Panel Report

Yarra Planning Scheme Amendment C220 Johnston Street Built Form Controls

22 February 2019

Panel Report pursuant to section 25 of the Act

Figure 5: Affected VicRoads land

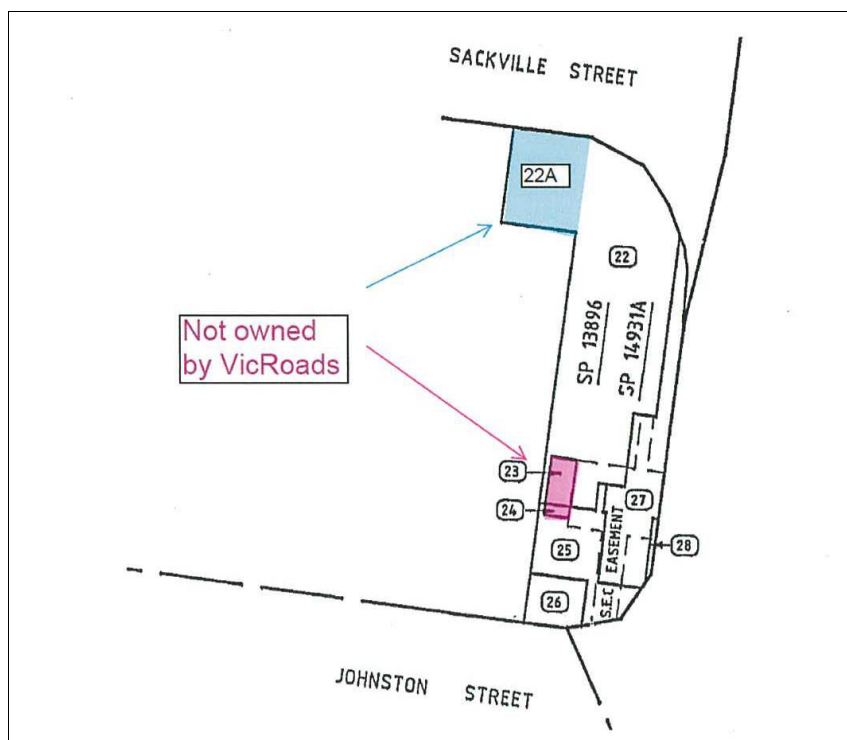
VicRoads advised that the land comprises seven separate parcels (Figure 5 and Table 3), two of which are owned by CitiPower and occupied by an active substation. It is noted that parcel 22A (also known as 165 Sackville Street) was sold by VicRoads in 2017 and is currently owned by Aheron.

Having regard to the above, VicRoads in consultation with Transport for Victoria, CitiPower Pty and Powercor Australia Ltd requested the anomalies in the planning scheme map be corrected to:

- show the relevant parcels of land as a Road Zone Category 1
- correctly identify CitiPower's land as a Public Use Zone 1 or Public Use Zone 7.

Rezone the VicRoads land on the northwest corner of Johnston Street and Hoddle Street, Collingwood to Road Zone Category 1 and delete Design and Development Overlay Schedule 15.

Rezone the CitiPower land near the northwest corner of Johnston Street and Hoddle Street, Collingwood to Public Use Zone (PUZ1) if compliant with the *Ministerial Direction – The Form and Content of Planning Schemes* and delete Design and Development Overlay Schedule 15.

Figure 7: Council Part B version preferred envelope

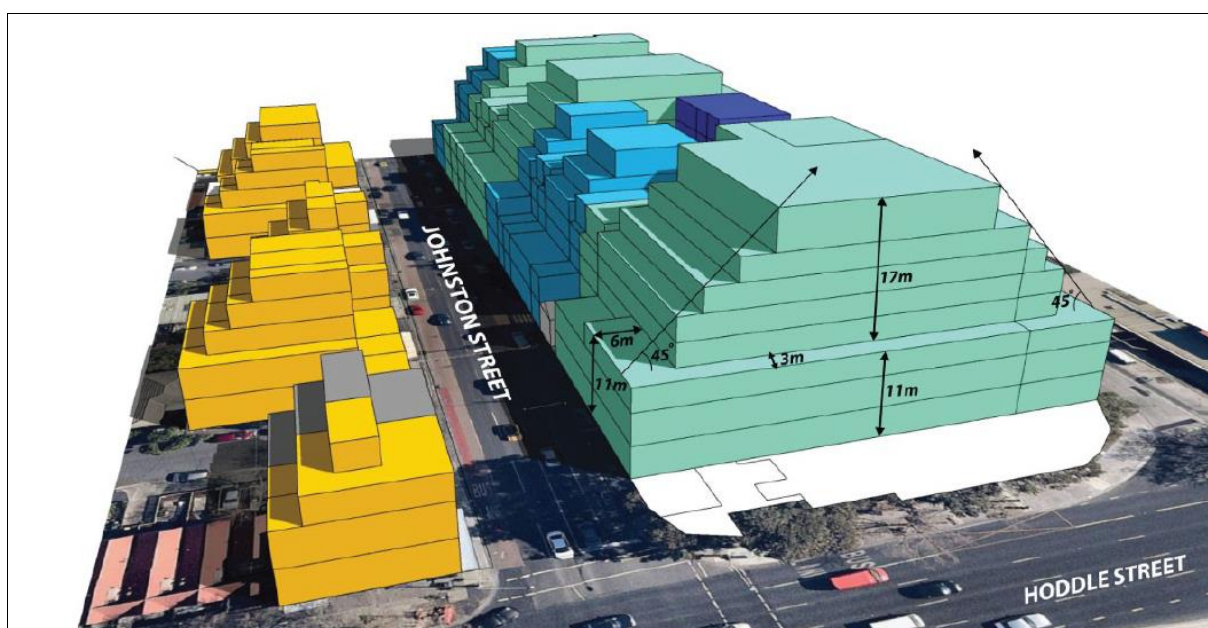
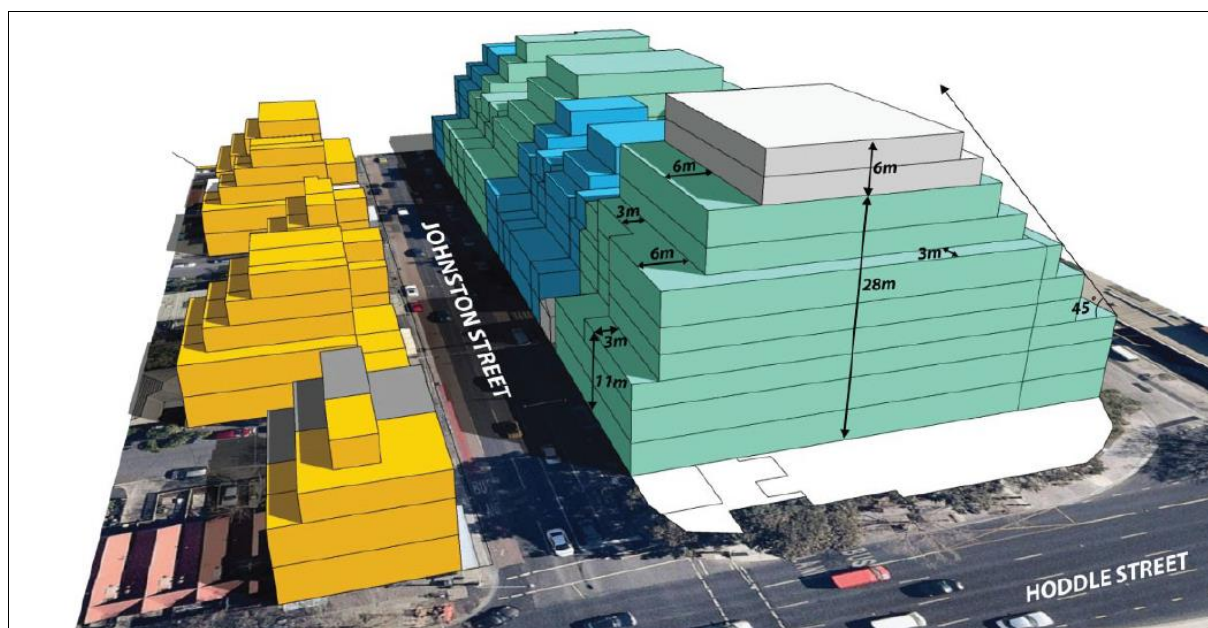
The Aheron submission – see Figure 8 – sought:

- a stand-alone precinct
- an exemption from the (discretionary) 45 degree envelope
- discretion to allow the 6 metre setback above the street wall to reduce at the eastern end
- a greater preferred height (34 metres rather than 28 metres)
- to enable the site's 'gateway role' to be recognised.

Figure 1: Building envelope requirement

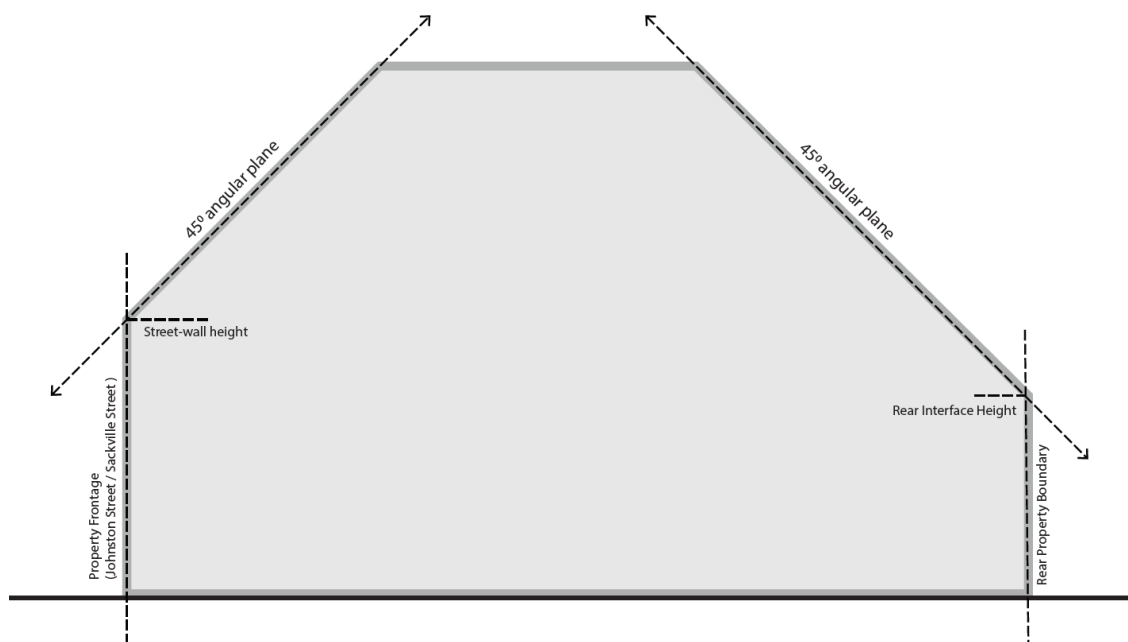
UPDATE DIAGRAM TO SHOW MID LEVEL SETBACKS ABOVE THE STREET WALL
